EXXEL PACIFIC
GENERAL CONTRACTORS

Request For Information - 001

The Cora Apartments (19 W Harrison)

Subject:	**Foundation Wall Drainage Layout**	**Status:**	**Open**
Drawing #:		**Spec Sect #:**	
Addendum:		**Submittal #:**

Foundation Drainage Plan NTS 8

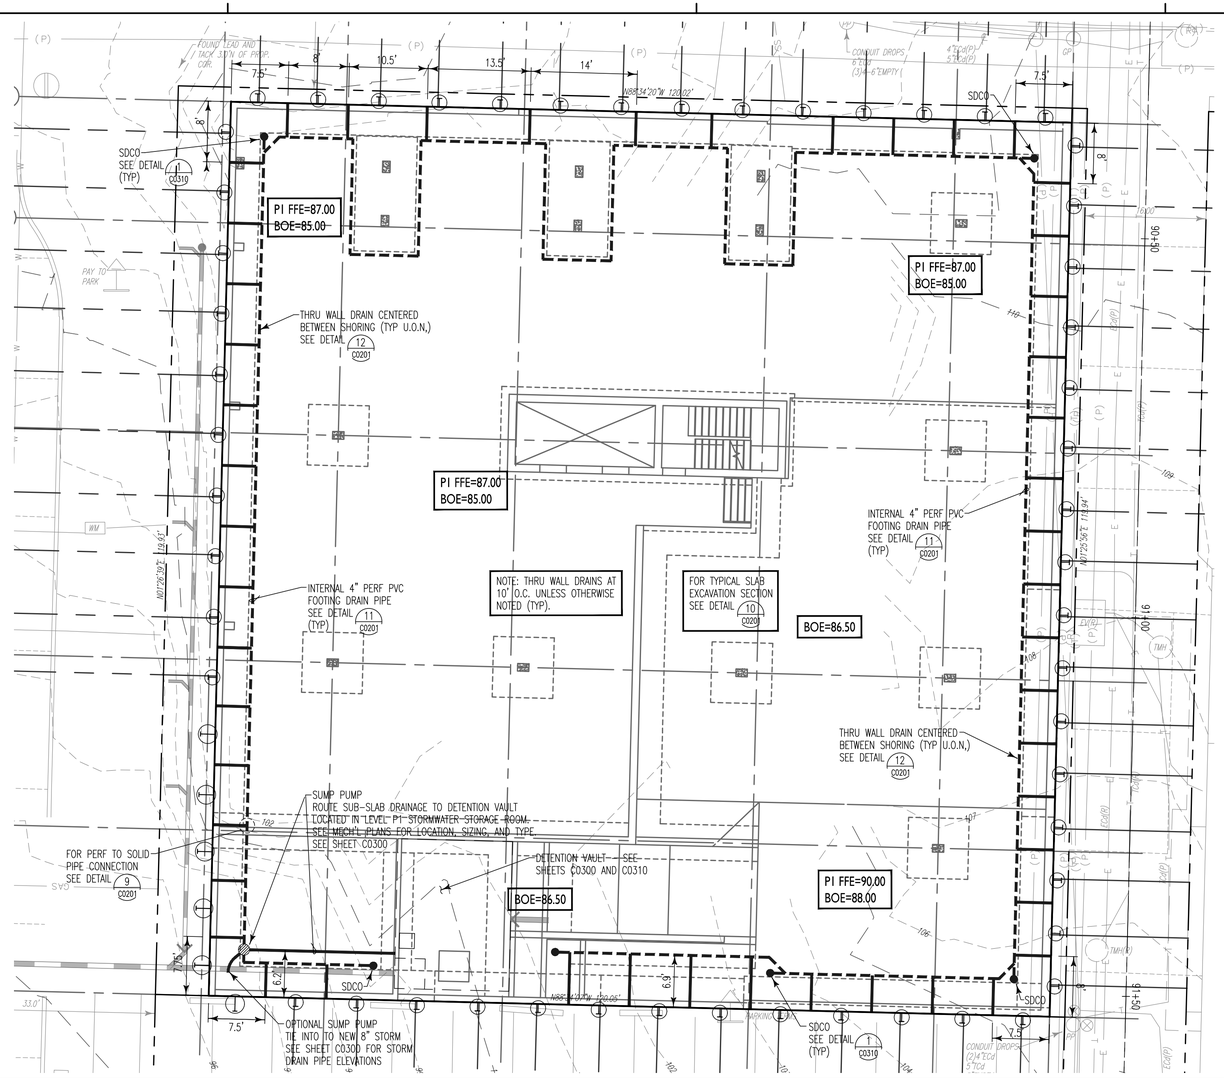
Please provide the foundation wall drainage layout, as requested in e-mail from Plumbing Subcontractor, Mike Donelson of OneWay in the e-mail, dated 3/15/2016. The layout is needed for their preparation of the underground plumbing shop drawings.

Victor,
We are still in need of a foundation wall drainage layout/design drawing from the civil engineer for the Cora project. We need this design as soon as possible to be able to complete our underground design drawings, including concrete basin depths.

In your response to **RFI 001 - Foundation Wall Drainage Layout**, you are showing a 4" PVC tightline in addition to 4" perforated PVC footing drain. Our plumbing subcontractor says that with so little ground water (per the soils report), most civil designs usually show 4" perforated PVC footing drain piping being used to pickup the foundation wall drainage weep lines (as shown on attached detail from civil drawings for another project). Is there any reason why the combined footing drain line wouldn't work for this project?

Date	Response
04/05/16	A new Foundation Drainage Plan, Sheet C0201 has been created - see attached, and to the best of our knowledge appears to meet Geotechnical Recommendations by Pan Geo Inc. per Geotechnical Report dated July 2014.

It is acceptable to have one single perf pipe for the wall/footing drain. Especially considering the next door has a deeper basement.

I agree that this is what is indicated in the Geotech report, but our design is similar to what we are doing for the project to the south at 1st and Thomas per coordination with another geotech on that project. Per the Pan Geo soils report, the borings were performed in the summer months and ground water levels were at ~20-ft below existing grade with some localized pockets at 7.5'-12'. During the winter months the groundwater level will be higher and could be almost half of the summer groundwater level or close to 10-ft below existing grade. The foundation will be deeper than 10-ft and close to 20-ft (maybe 18-ft at north end) in many areas, so that is why we show the double collector system with dedicated solid wall drain pipe and separate perf footin drain.

We would like Pan Geo to provide the final OK with the wall drainage being routed to a single 4" perforated drain pipe versus the double pipe system we show. If they are OK with it, then we will update our plan/details accordingly and re-issue as part of our response to the RFI. I have cc'ed Pan Geo on this email.
